GLIDER WINCHES & SPECIAL PROJECTS

Skylaunch Pulley Upgrade 2st July 2014

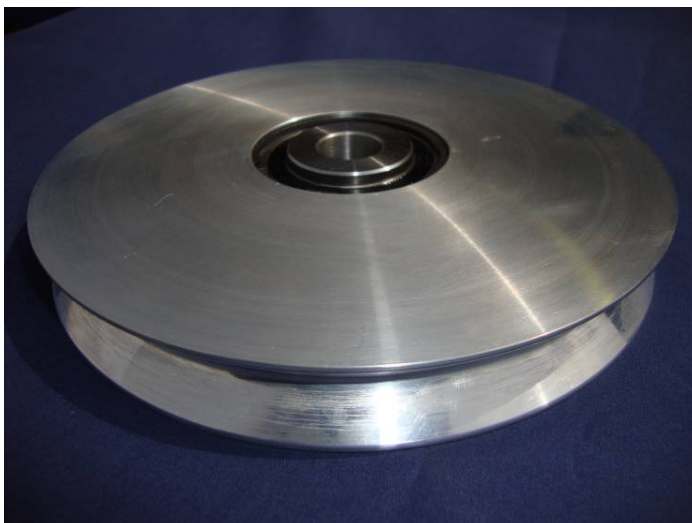
Skylaunch have developed a new design aluminium cable pulley assembly in cooperation with the British RAF GSA which directly replaces the top pulley in the pulley / roller heads for all clubs using synthetic cable.

The original lower plastic with steel hub pulleys can be retained, unless customers have a requirement to upgrade all their lower pulleys to aluminium.

The Aluminium units are designed to last longer than the plastic pulleys, and dissipate heat better.

The aluminium pulleys are fitted with a larger double row sealed bearing (spacers are supplied to reduce the bore allowing fitment of the original 20mm mounting bolt).
